Ledyard Inland Wetland & Watercourses Commission
741 Colonel Ledyard Highway
Ledyard, CT 06339

We are in receipt of Groton Utility comments for the residential project located at 1947 Center Groton Road. Our responses are shown below in bold italic type and are as follows:

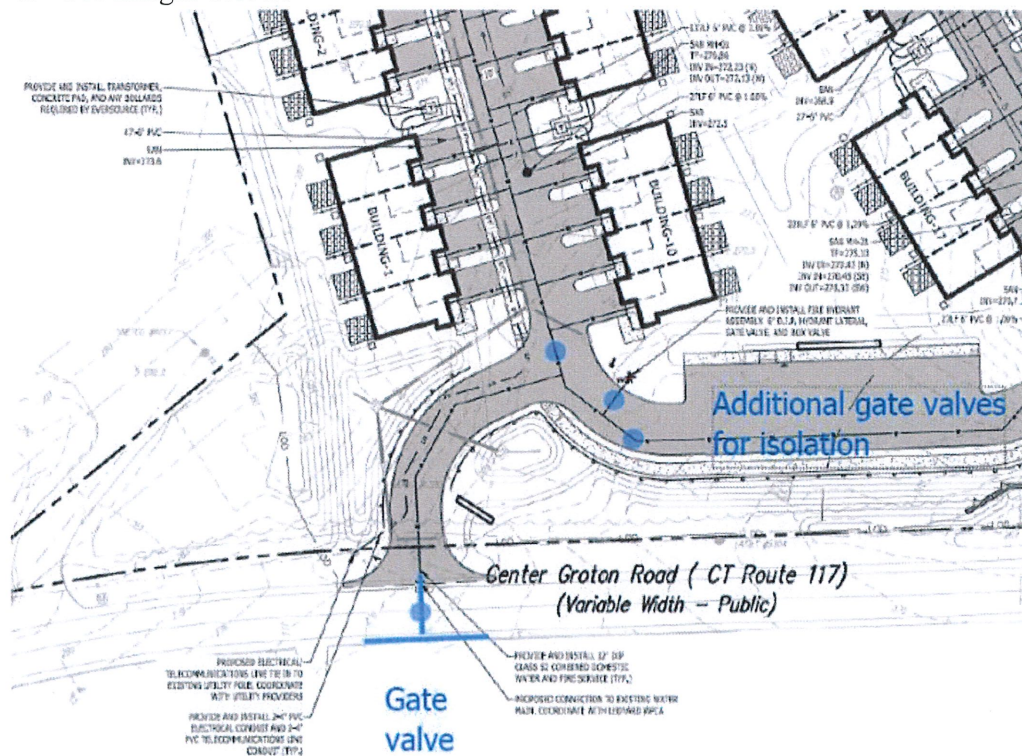
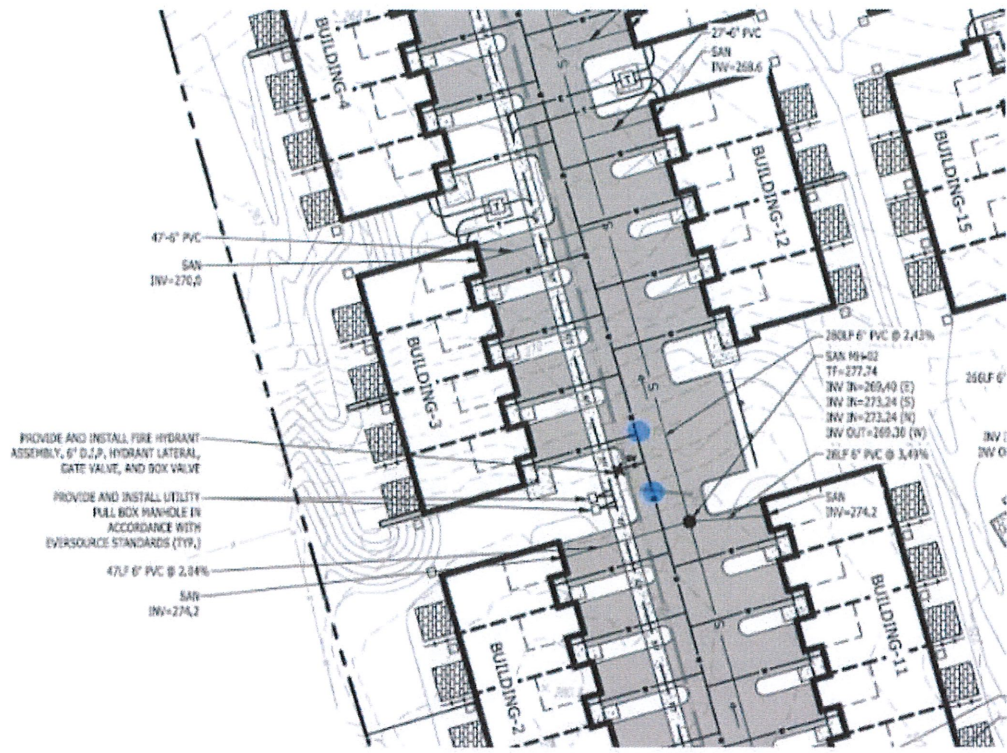
5. Please indicate pipe size and material of services, as well as a Spec detail of the “combined domestic and fire service” as noted on the Plan.

Response: *Pipe size and material is indicated on the plan as 12” ductile iron pipe (DIP) class 52 for the loop main and 1” type K copper for domestic services to each building. Refer to sheet C3.00.*
